**Staff Report to the  
Municipal Planning Board  
October 18, 2022**

**MPL2022-10009  
ADDENDUM**

## ORLANDO GATEWAY APARTMENTS

# Site Plan

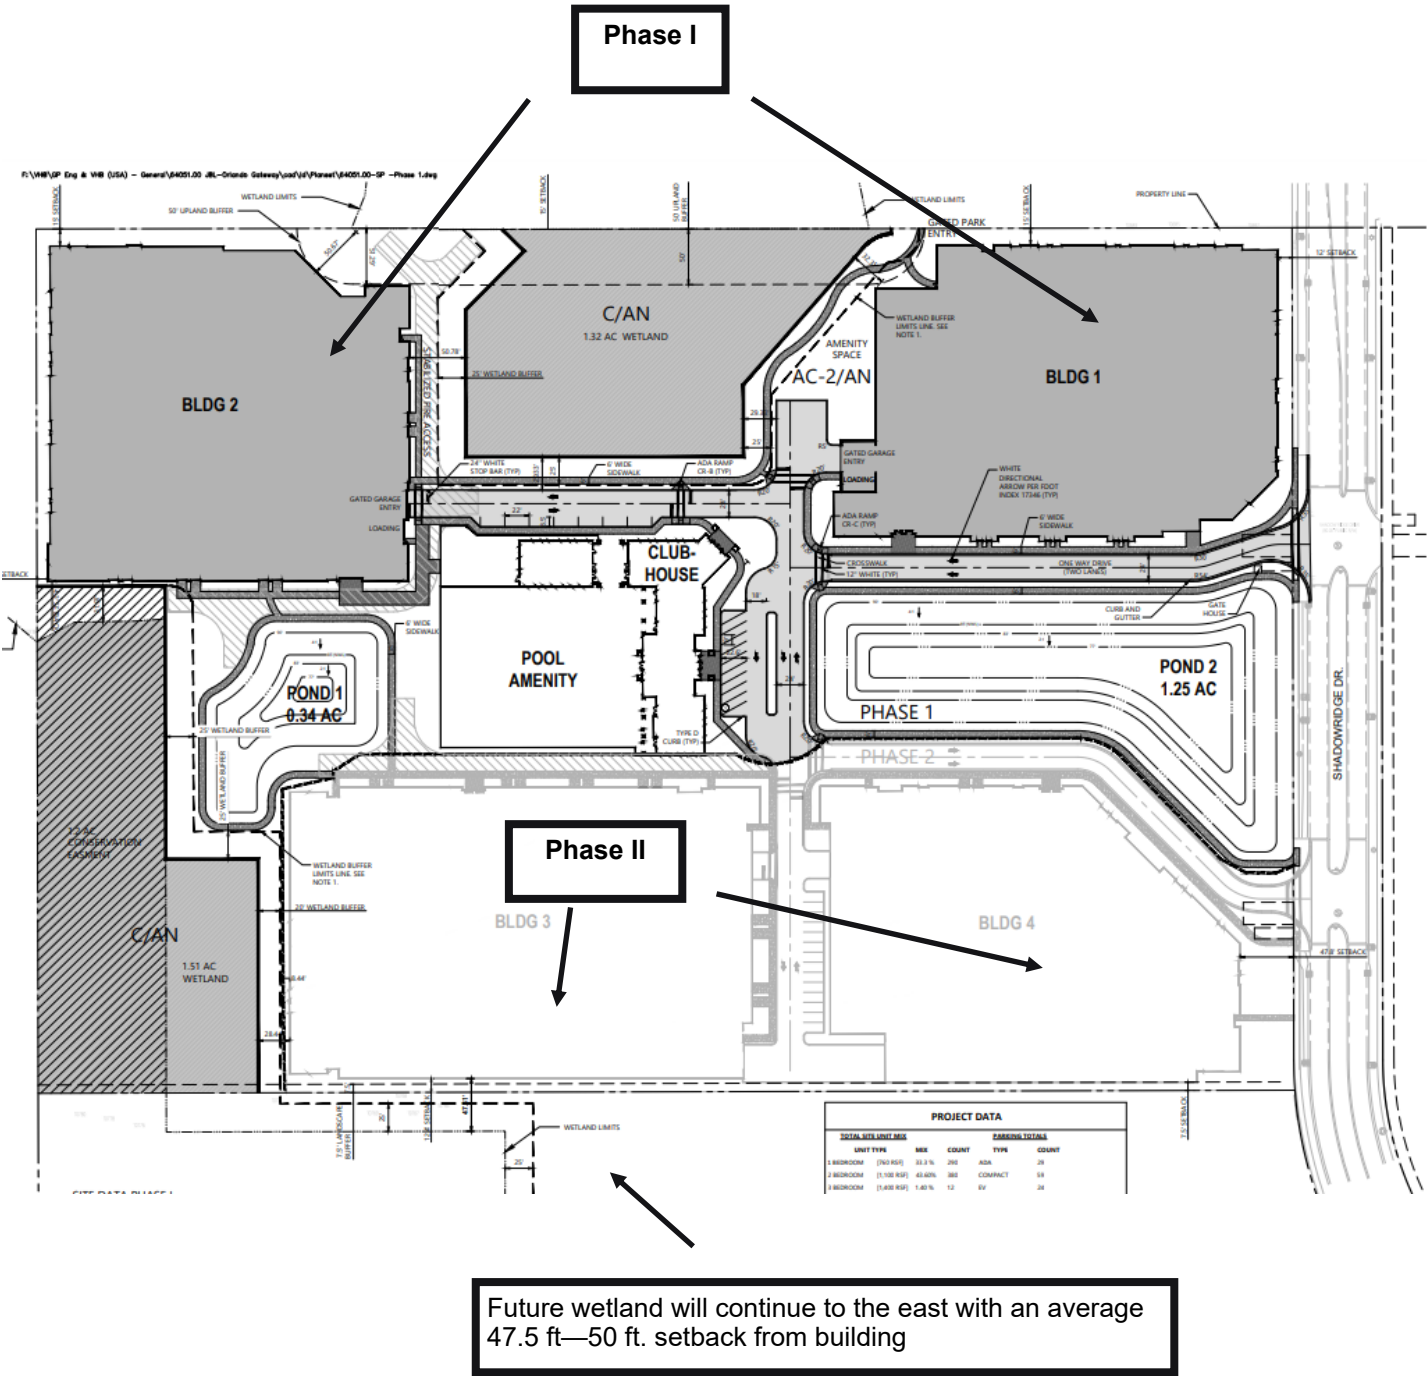
9. This property is required to plat in accordance with Section 65.401 of the City's Land Development Code prior to the issuance of building permits.
10. Based on the conceptual site plan the phase line needs to be adjusted to reflect the two outgoing (exiting) traffic lanes shown with this project.

# Landscape Plan

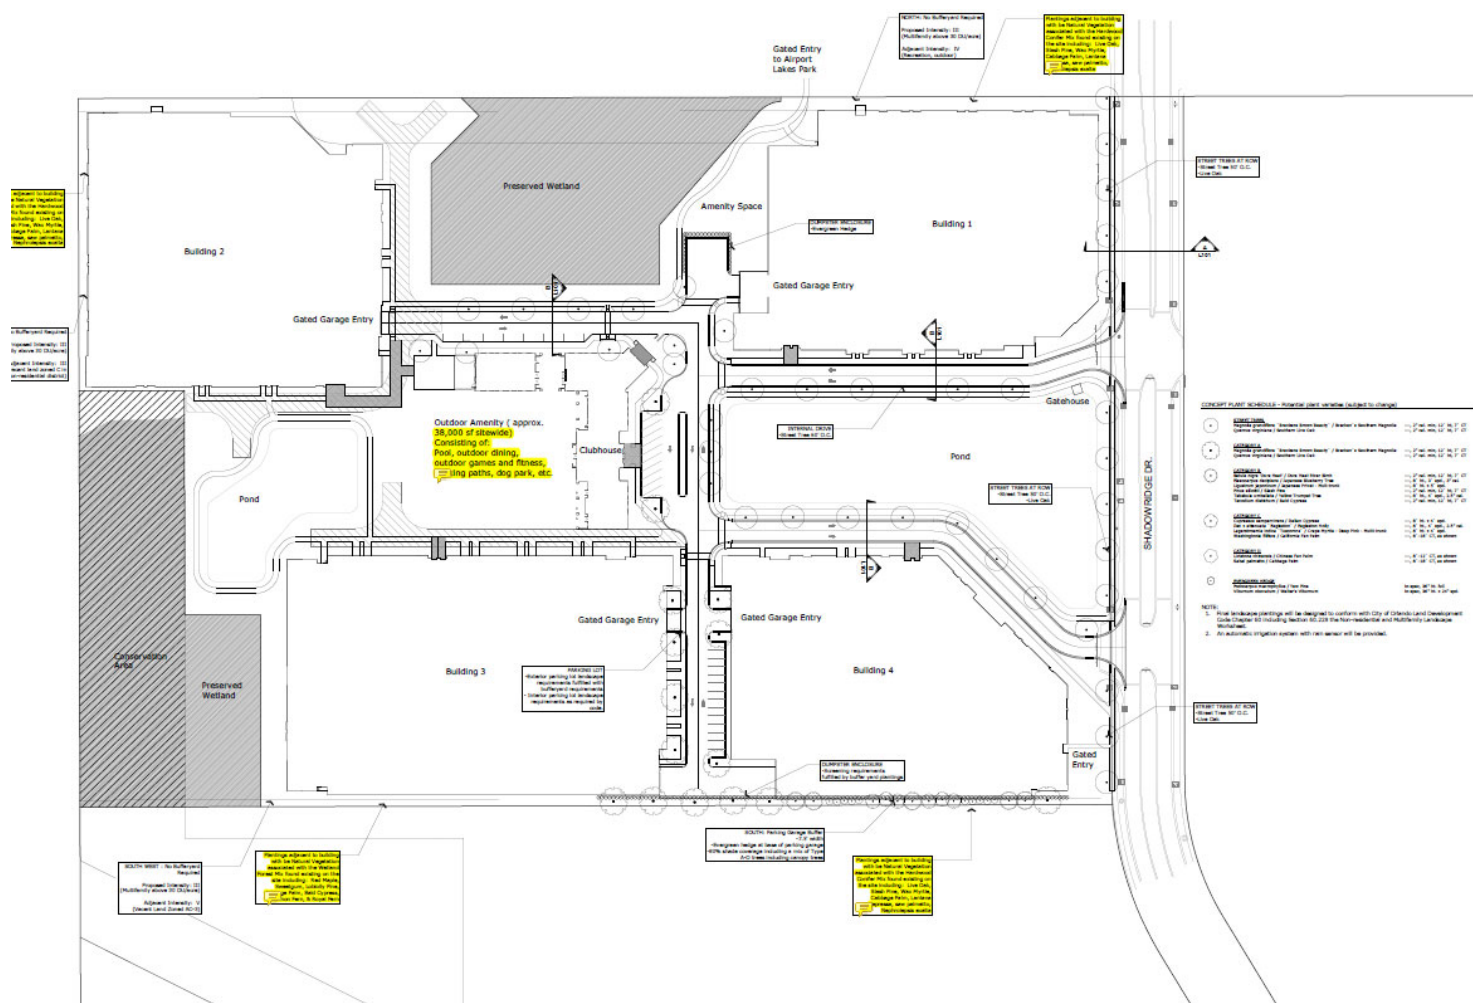
5. Street trees proposed along the pond must be Live Oaks.
6. The proposed eastern pond must be treated as a site amenity per Section 60.144. This shall be accomplished by the following:

- i. Planting at least 15% of the length of the pond's edge in a planting area at least two feet in width above and below the mean water elevation pursuant to the following formula:  
Length of Pond's Edge x 0.15 = Result (Y)  
 $Y \times 2 = \text{Required Landscape Area}$

- ii. at minimum 2 fountain jets.
  - iii. The storm water ponds can act as a source for landscape irrigation water. This is encouraged.
